CERTIFICATE OF APPROPRIATENESS

RE: Application Number 21-7582 and 21-7583; 9710 & 9730 Outer Dr. (15770 Minock); Rosedale Park Historic District

9710 & 9730 W Outer Dr - Upcoming HCD Submission

From: [Christoph Ibele](#)
To: [Dan Rieden](#)
Cc: [Nicole Fricke](#)
Subject: [EXTERNAL]Re: [EXTERNAL]Re: HDC: 9710 & 9730 W Outer Dr
Date: Thursday, October 28, 2021 6:07:54 PM

Existing Wood Window Replacement

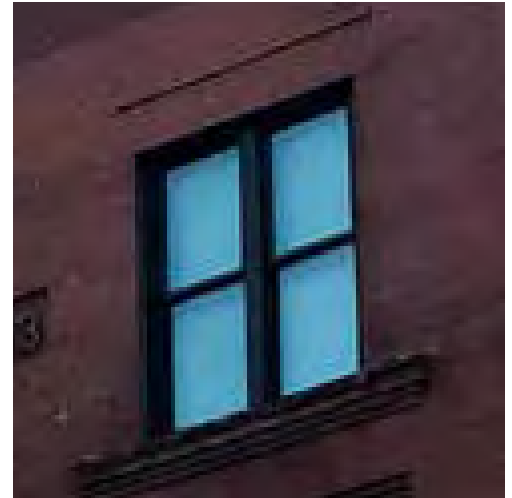
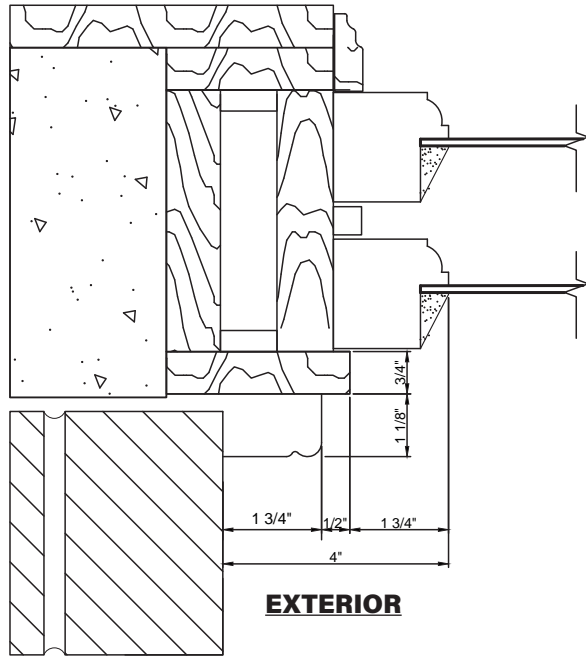
- Please provide an exterior view of the proposed windows, particularly those that match the sill detail on page 13. This can be a catalogue image that matches what is being proposed.

- Questions 3 and 5: the products we're proposing are used regularly for historic projects, and some of the required profiles (brick mould, muntin, mullion, etc), require a proposed custom die. So we're still waiting for a drawing of these custom profiles to be created - I can provide these drawings as soon as they're available. In the meantime I've added exterior views of the base products on pages 13, 14 and 16. Not all sections will not be 1 over 1; they will match the existing muntin patterning shown on the Window Types & Schedules sheet (A4.0.1), p262 of the document. Muntins will be 3-part simulated divided lites (SDL) with an external muntin bar on both the outside and inside of the window

Existing Steel Window Replacement

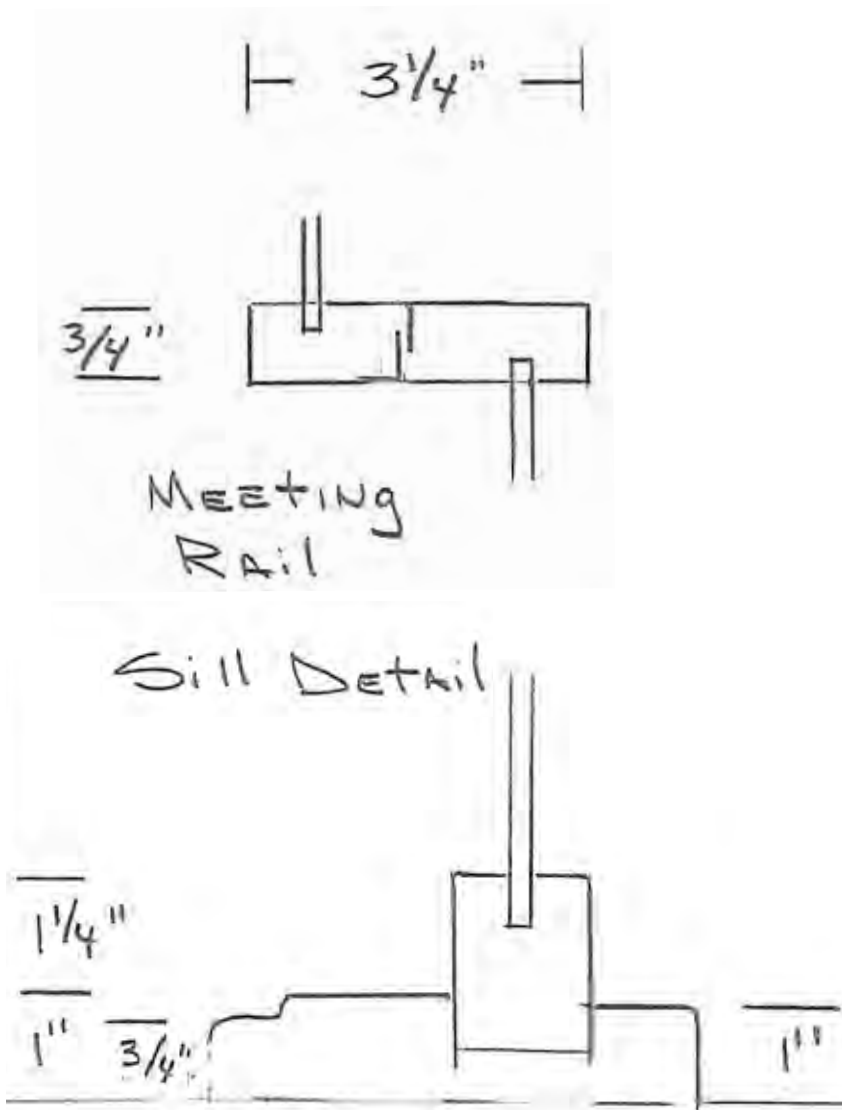
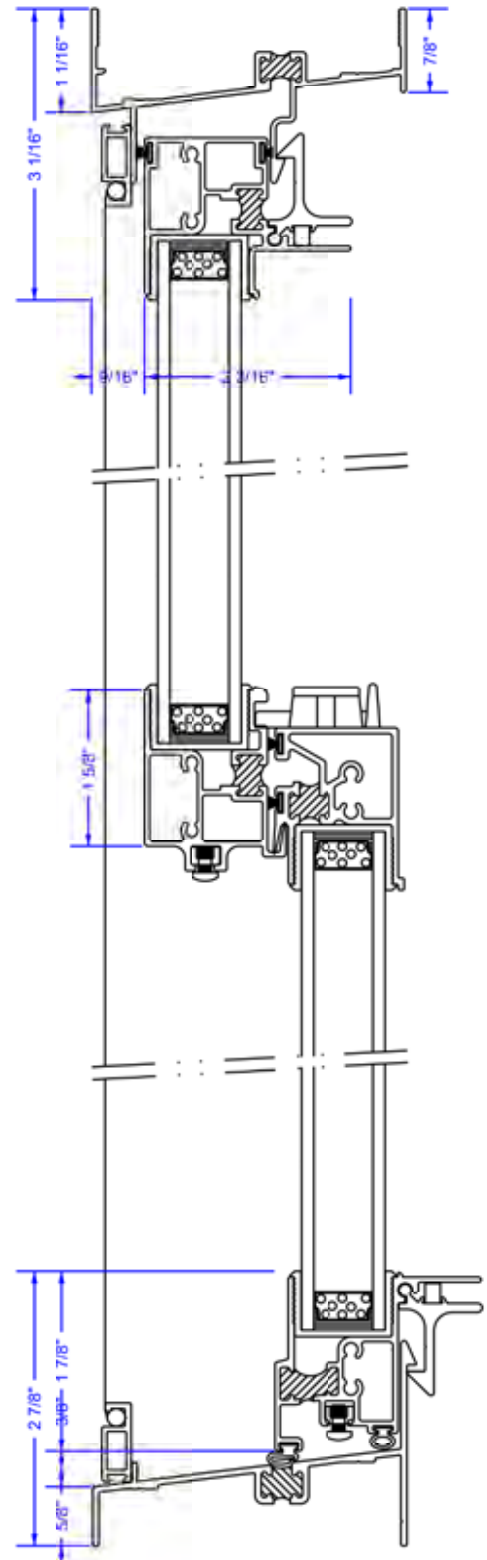
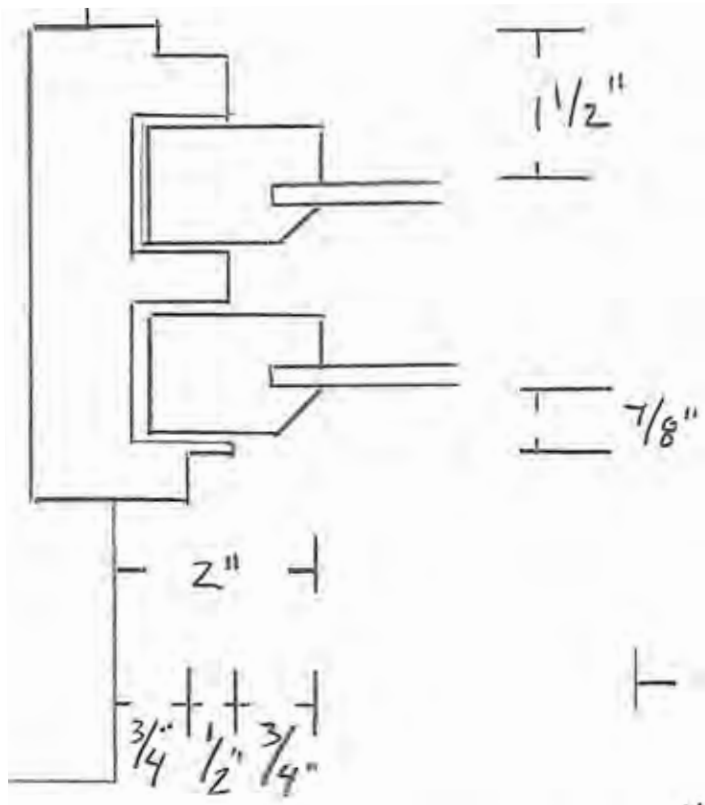
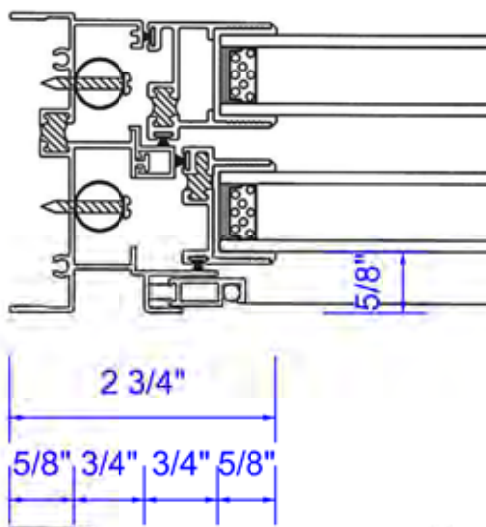
- Page 15 is an example where some headers don't appear to match the content. The header says "wood" the content says "steel". Also, not clear on the existing vs proposed sections on the steel drawing. Need clear labels. So as to not confuse the Commission, please review the document for these labels, correct and resend PDF.

- These section profiles appear to be missing the muntins and mullions. We'd like to see the existing and proposed profiles for these too. All sections appear to be 1 over 1... is this true?

- Question 4: please see link below to updated pdf - hopefully this clears up the confusion
- Question 6: we intend to replace mullions with factory-mulled units to help ensure the best possible fit and thermal performance
